June 2021 BAR Decision

BAR 21-06-06

905 Rugby Road, TMP 020076000

**City of Charlottesville
Board of Architectural Review
Staff Report
June 15, 2021**

Existing footprint and proposed new.

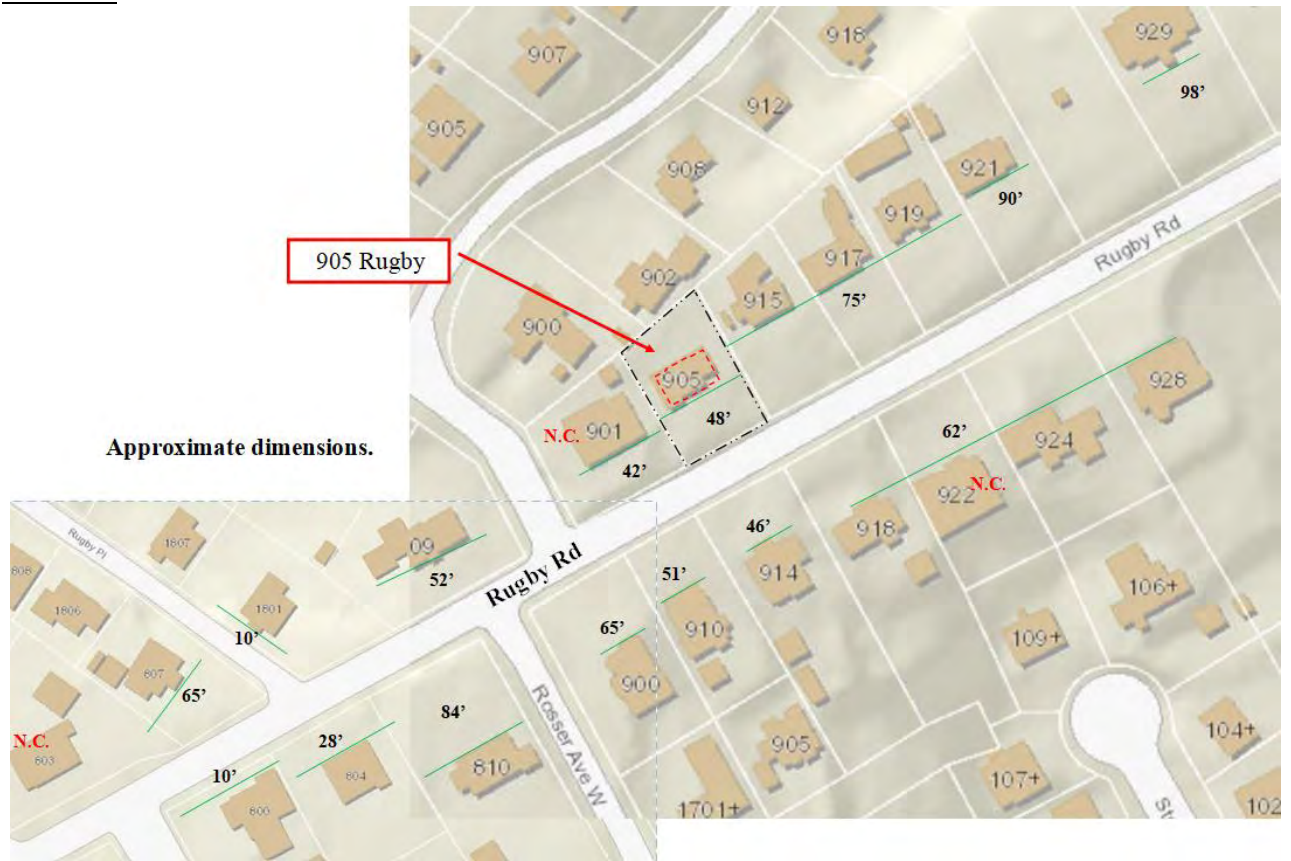
Staff Comment: While the existing house is non-contributing, the setbacks, spacing, and width are consistent with other, contributing properties in the district. The proposed residence is approximately in the same location and within the same footprint of the existing house. The increase in height is compatible with the district.

SITE PLAN

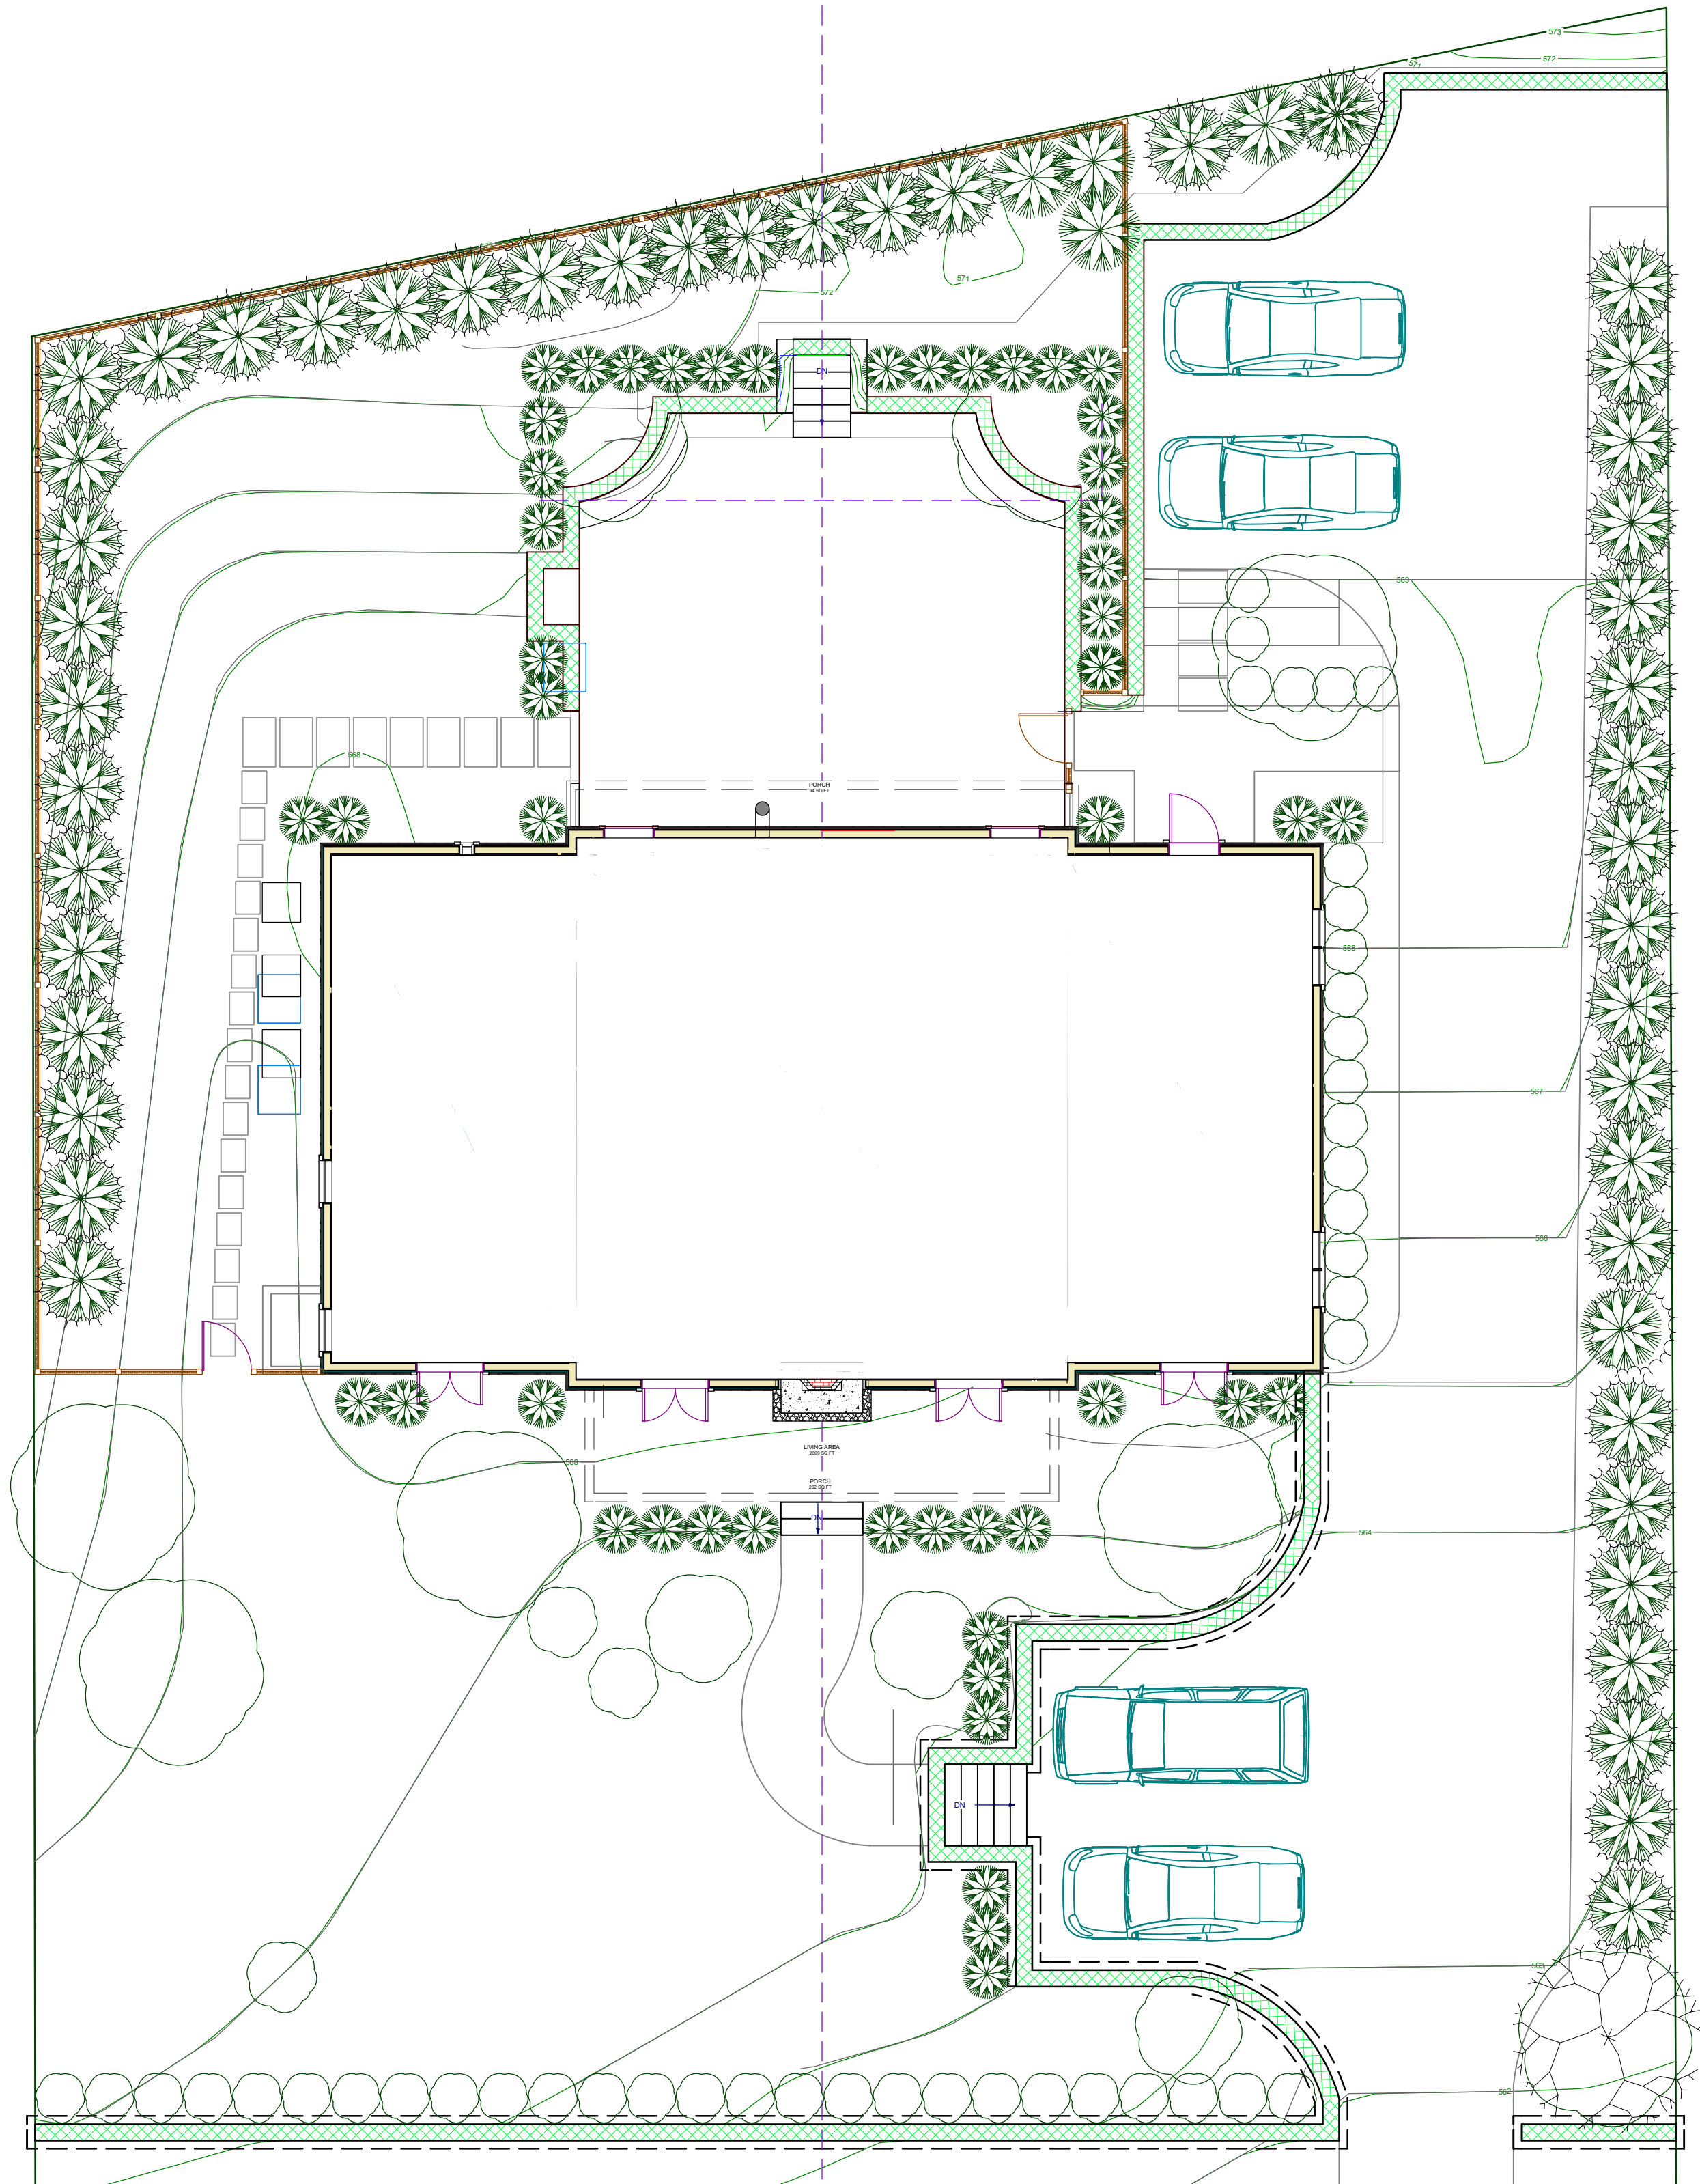
Tim Mohr moves: Having considered the standards set forth within the City Code, including City Design Guidelines for Historic Conservation Districts, I move to find that the proposed residence and landscaping at 905 Rugby Road satisfy the BAR's criteria and are compatible with this property and other properties in the Rugby Road Historic Conservation District, and that the BAR approves the application with a request to introduce street trees along Rugby Road.

Staff Comment: Proposed wood fence is at the side yard and rear.
